STAFF RECOMMENDATION

**1800 Holly Street
May 21st, 2014**

Application: New construction—outbuilding; Conversion—detached accessory dwelling unit

District: Lockeland Springs-East End Neighborhood Conservation Zoning Overlay

Figure 5. The existing outbuilding is located behind the historic house.

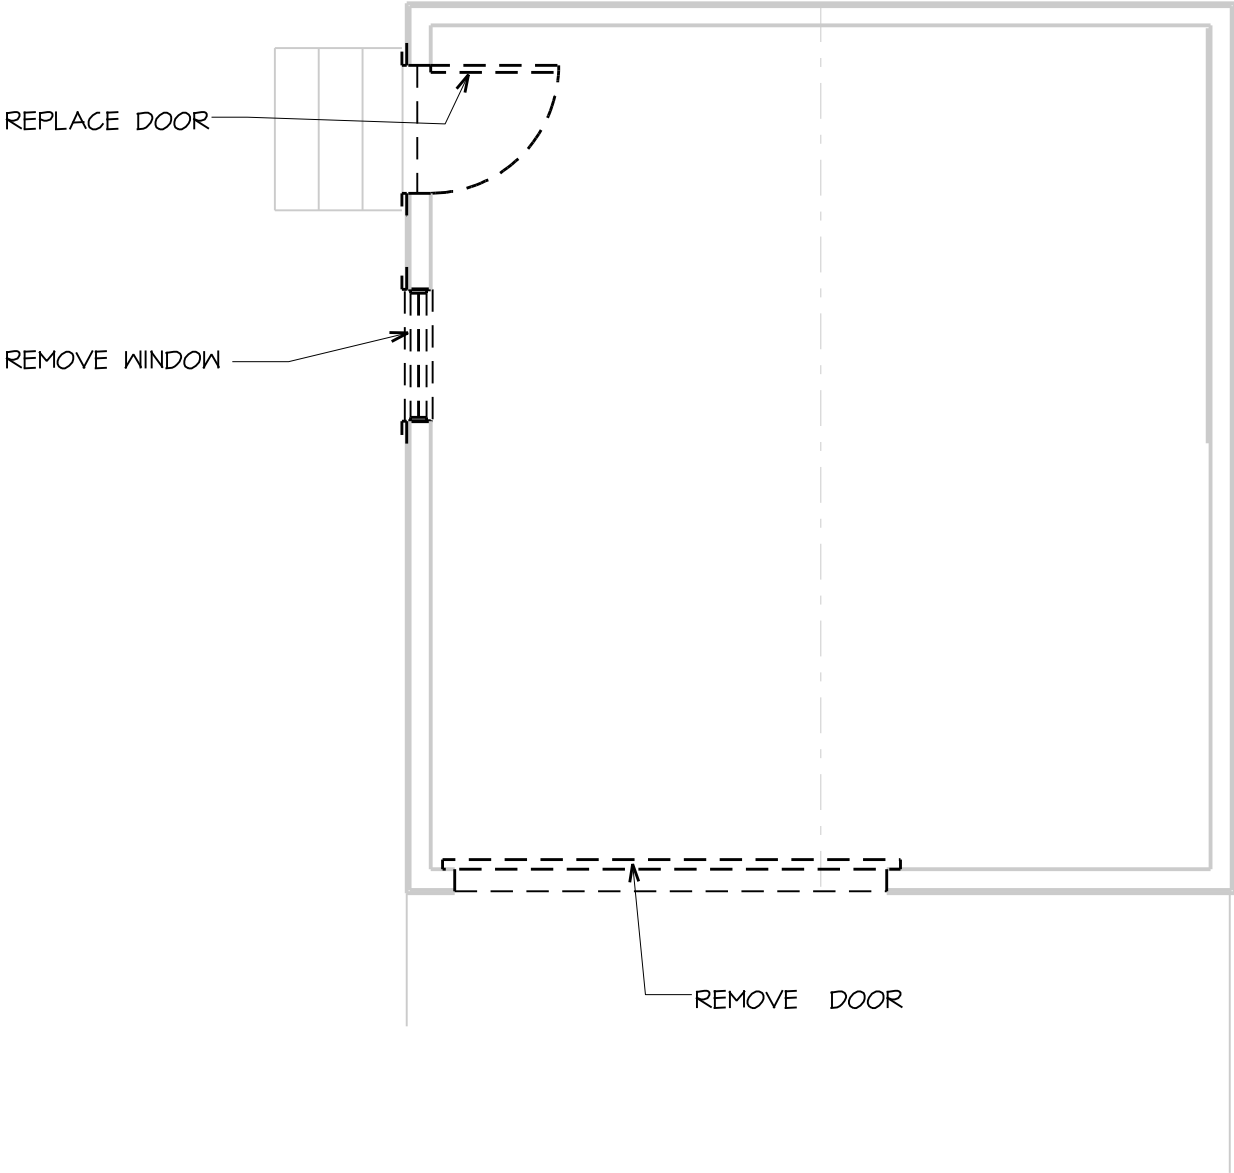
Site Requirements. The detached accessory dwelling unit is located in the rear yard of the primary structure at 1800 Holly Street (Figure 5). There will be approximately twenty-seven feet, four inches (27'4") between the primary residence and the accessory structure. The structure therefore meets Standard 5 of the Detached Accessory Dwelling Unit regulations.

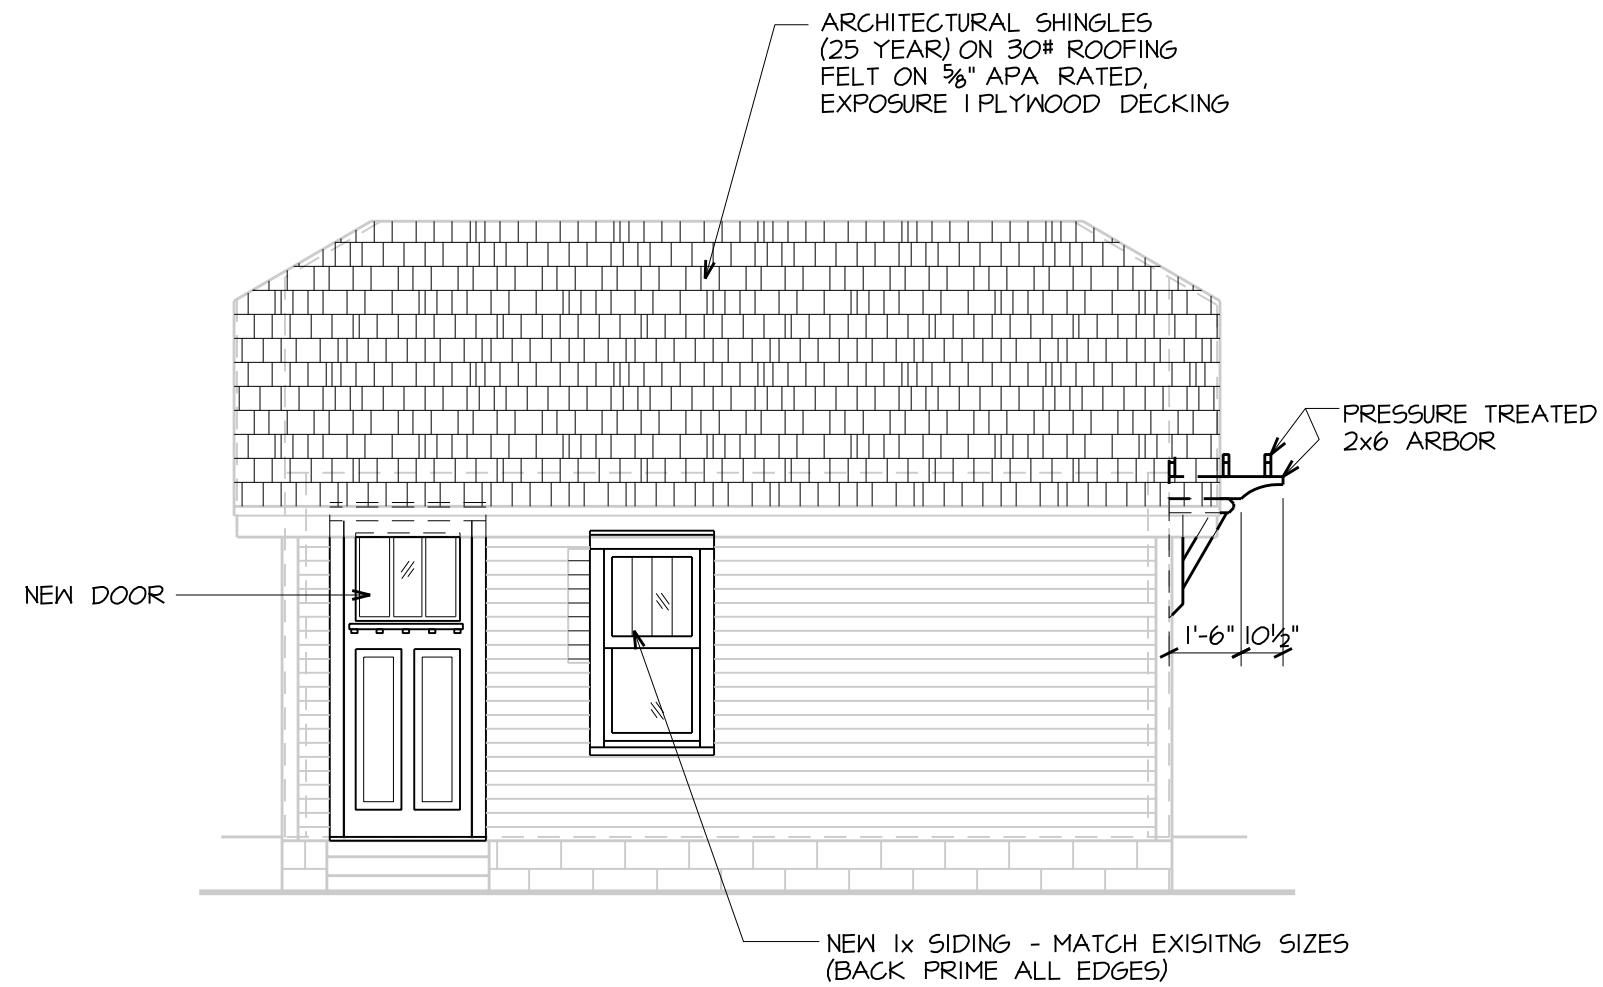
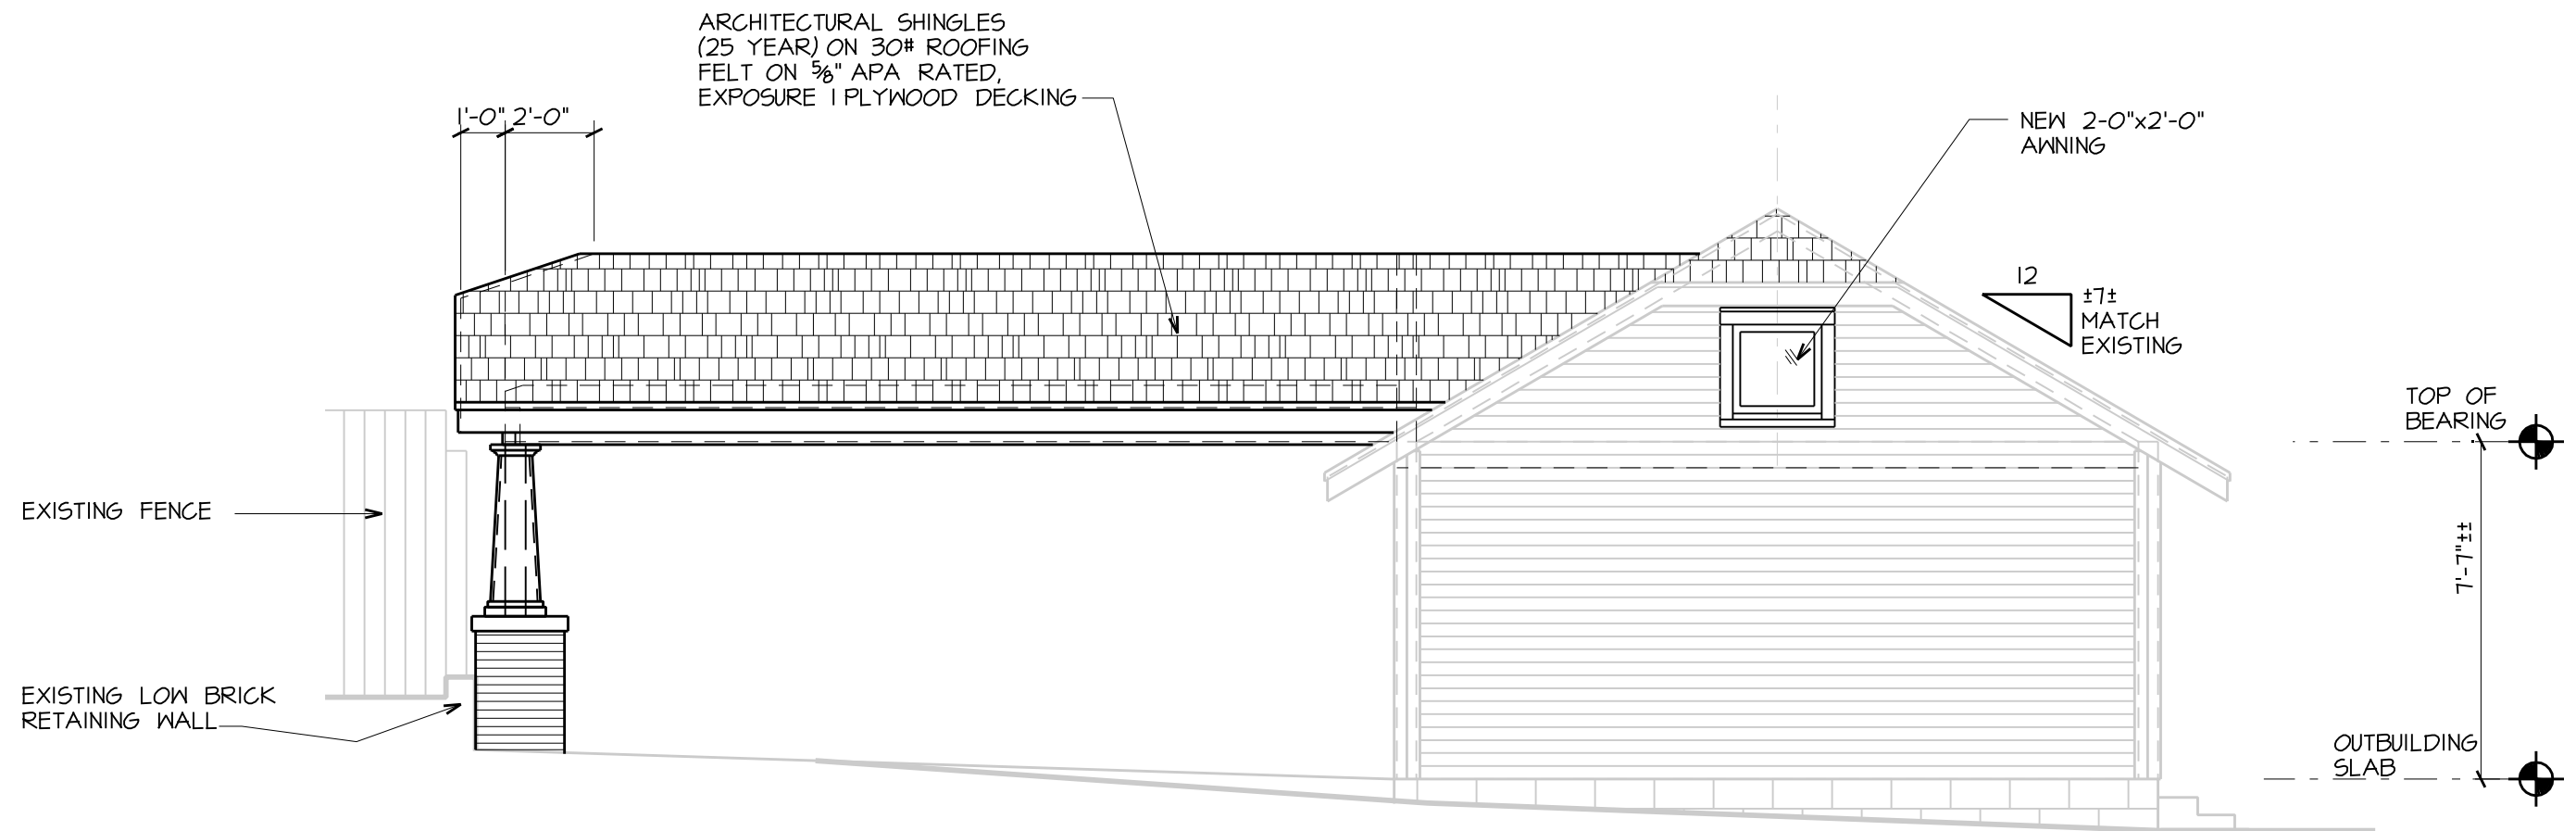
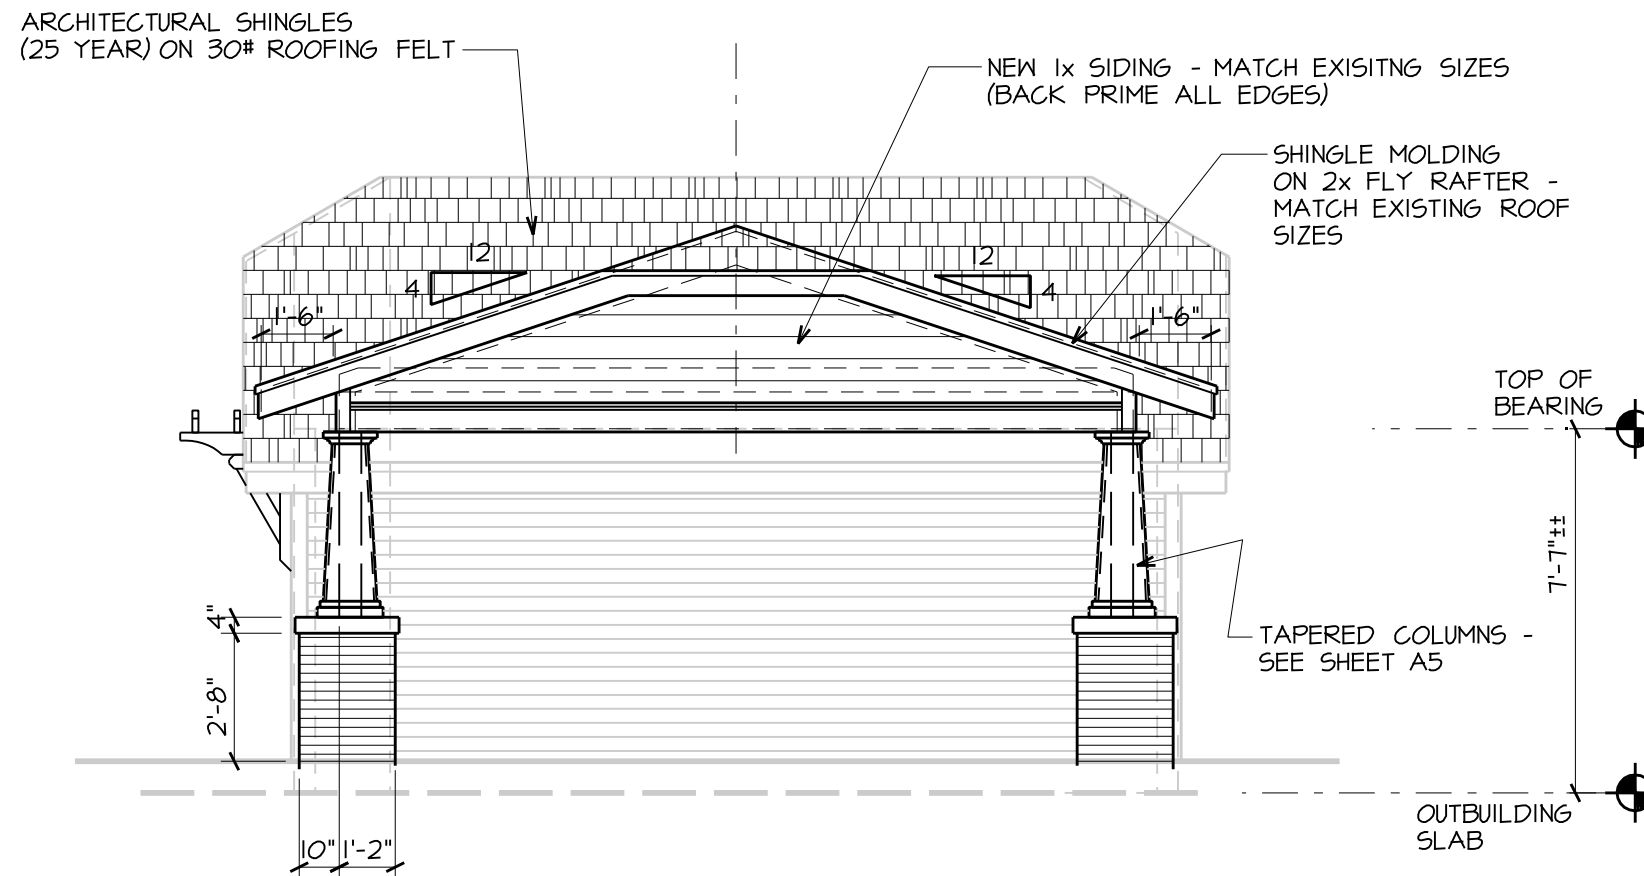
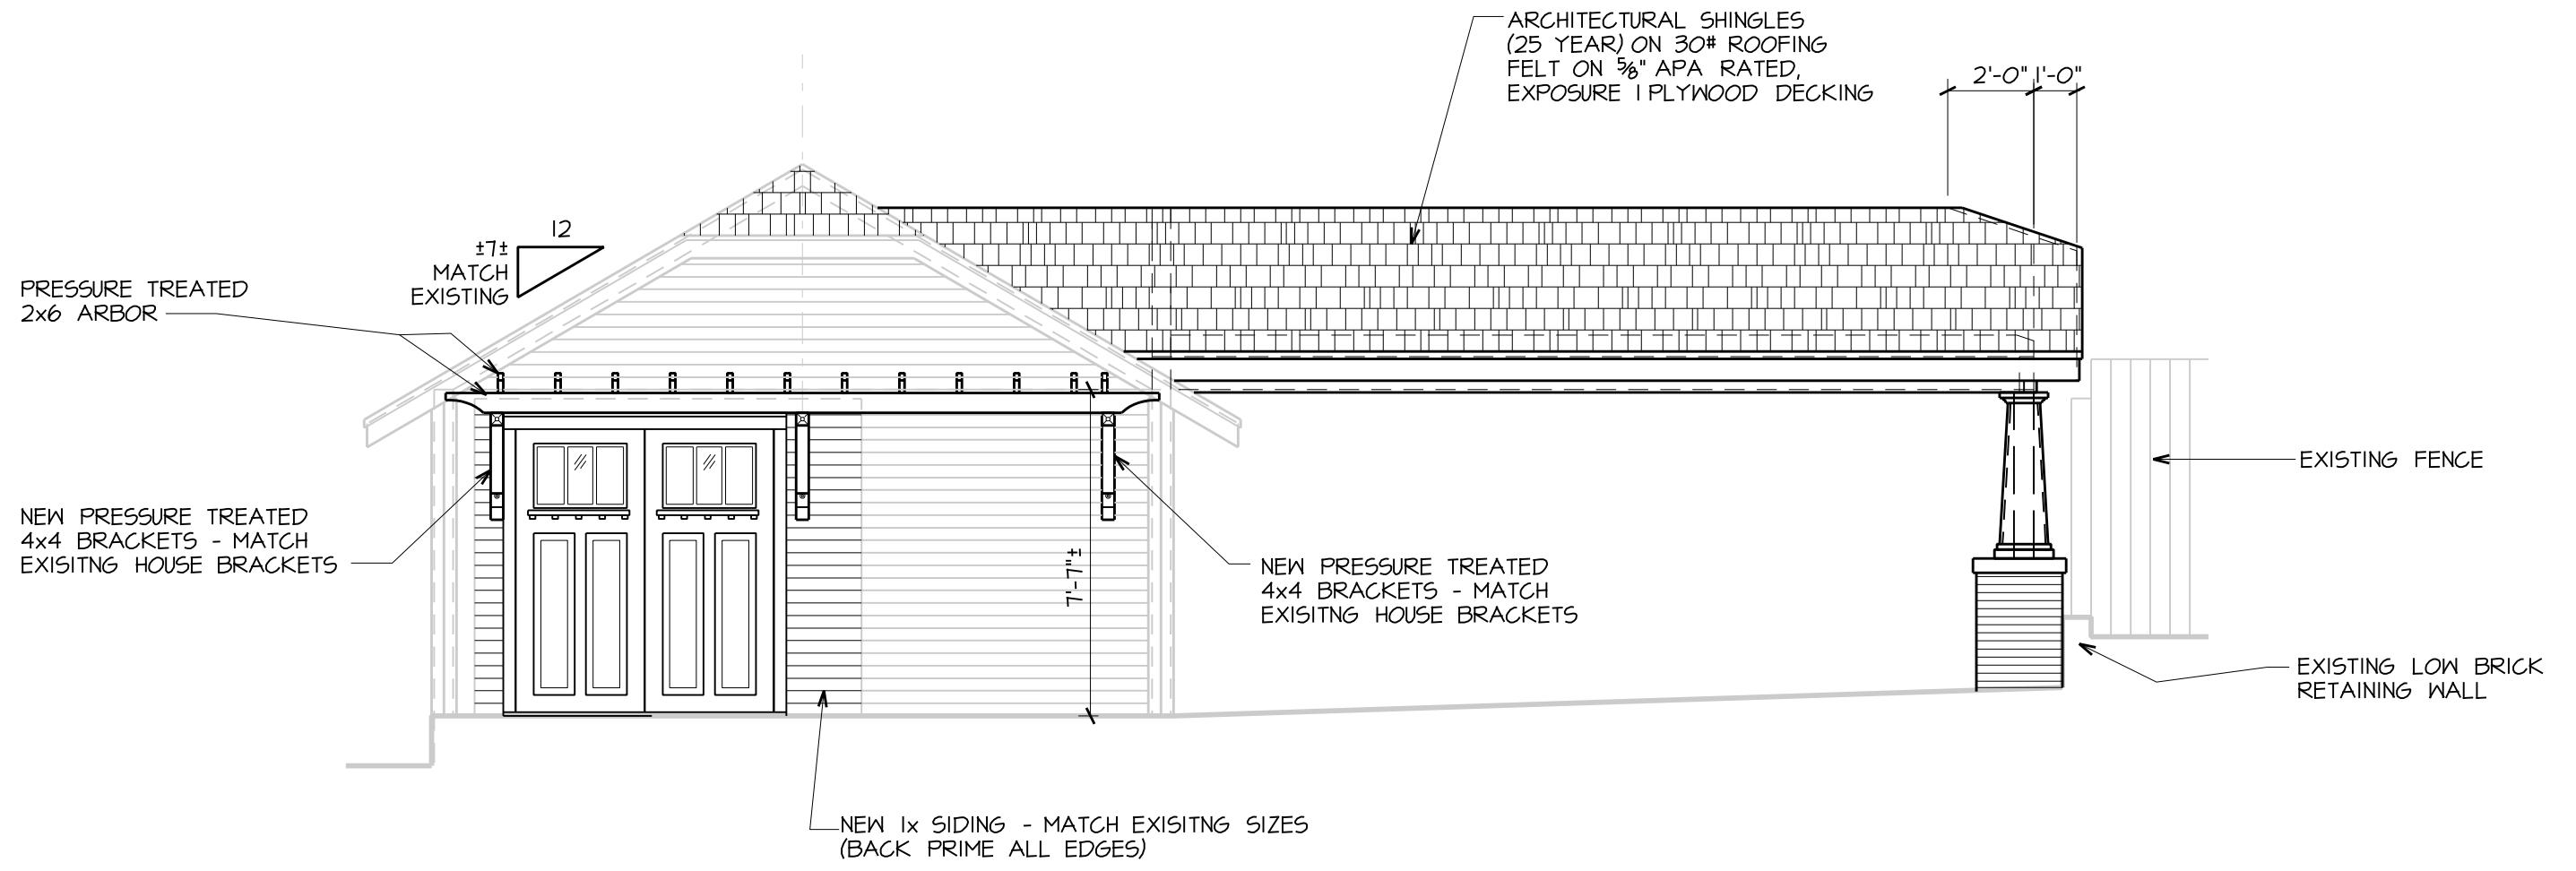
Bulk and Massing. The existing outbuilding and the new carport are both one story tall. Their combined footprint is approximately six hundred and forty-two square feet (642 sq. ft), less than the maximum footprint of seven hundred square feet (700 sq. ft.) for one-story structures. The existing structure has an eave height of six feet, three inches (6'3") and a ridge height of twelve feet, nine inches (12'9"). The new carport will have an eave height of seven feet (7') and a ridge height of eleven feet, six inches (11'6"). These eave

and ridge heights are subordinate to the historic house, which has an eave height of ten feet, six inches (10'6") and a ridge height of twenty-three feet (23'), and they are less than the maximums set by the DADU ordinance. The structure meets Standard 7 of the Detached Accessory Dwelling Unit regulations.

Roof form: The existing outbuilding has a clipped gable roof with a slope of approximately 7.5/12. The new carport will also have a clipped gable form with a slope to match that of the existing outbuilding. These roof forms match the historic house's roof form. Staff finds that the DADU and the carport's roof forms meet section II.B.8. of the design guidelines.
